Meeting Minutes: Plumbing Board

Date: July 16, 2019
Time: 9:30 a.m.
Minutes by: Lyndy Logan
Location: Minnesota Room, Department of Labor and Industry
443 Lafayette Road No., St. Paul, MN 55117-4344

C. Request for Final Interpretation – Robert Christensen – Section 602.2, et al.

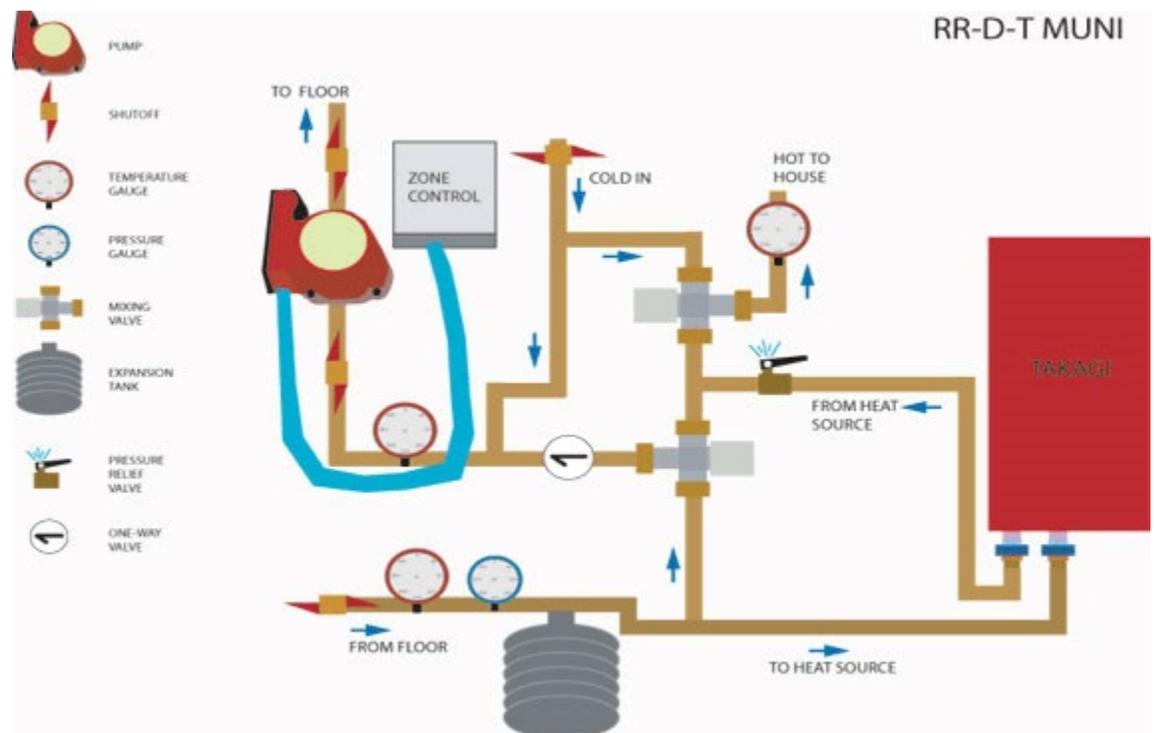
Christensen addressed the Board – **see Attachment A** – and said that MN Rule 4714.602.2 states that water used for cooling or heating of equipment or other purposes shall not be returned to the potable water system. The system Christensen wants to install does not return water used for cooling or heating of equipment or other purposes to the potable water system as described in 4714.602.2, the water within the system always remains potable as it is part of the system. Christensen said that in the domestic hot water open loop system, the potable supply water can only enter the system via the NSF-rated PEX tubing used for radiant heating. This is made possible by an NSF-rated check valve which ensures the supply water will never become stagnant in the tubing because it cannot bypass the radiant tubing and flow directly to the NSF-rated Takagi on-demand hot water heater that is designed for this purpose and follows manufacturer guidelines. Furthermore, the system protects the potable supply water by means of an NSF-rated backflow device as prescribed within the code.

When the system requires heat, the thermostat turns on an NSF-rated circulating pump and allows the hot water to flow through the check valve and enter into the supply system and operates in the same pre-described method as found in 4714.601.1.2 "Hot Water Recirculation." It passes through the on-demand hot water heater and is

tempered by a mixing valve as required in section 1002, Water Heaters, of the 2015 Minnesota Mechanical and Fuel Gas Code ("1002.2 Water heaters utilized for space heating. Water heaters utilized both to supply potable hot water and provide hot water for space-heating applications shall be listed and labeled for such applications by the manufacturer and shall be installed in accordance with the manufacturer's installation instructions and the International Plumbing Code") before entering the domestic hot water portion of the system.

Jobe advised the Board to make a determination on the RFI. Is the water used for floor heating, equipment or other purposes? Did it ever leave the potable water system? Would 602.2 be applicable to the drawing Christensen submitted?

There were multiple types of systems and details of heating systems discussed. Becker said in his opinion the drawing submitted (diagram above) meets the 602.2 requirements of the code, assuming all the piping is new and wasn't used previously for something other than potable water.

Tran stated that the question to be interpreted should be broader and not specific to this particular situation as the diagram is only one of many types of combination water heating and space heating systems. The question to be interpreted can be, do combination water heating and space heating systems violate Code Section 602.2? Jacob further stated that the Board should only deal with the specific RFI and not the broader question. Jacobs added that the question should be does the system as described in the RFI, and as presented, violate section 602.2?

Board discussions and questions on the specific system on Mr. Christensen's RFI. Mr. Christensen clarified he is intending on reusing the existing piping from his previous hydronic system for the new combination water heating and space heating system. He was advised the reuse of the existing underground hydronic piping is a violation of the code (Section 604.7) and he will not be able to reuse any existing hydronic piping for potable water systems.

Jacobs told Christensen he could submit two new RFI's – one for his specific project and another to specifically state what needed interpretation from the Board. This would allow the opportunity to comment on one of the diagrams, not the two different systems that were submitted in the RFI. Christensen said he understands now that he is not allowed to reuse the existing piping.

Jacobs suggested that Christensen submit a new RFI with a schematic of the system and a material list, and whether the RFI is specific to a specific project or a general question in regard to combination domestic and space heating. Because Christensen submitted two different drawings, Jacobs said that two RFIs could be submitted if both issues needed to be addressed.

Christensen withdrew his RFI and said he would submit a new one.
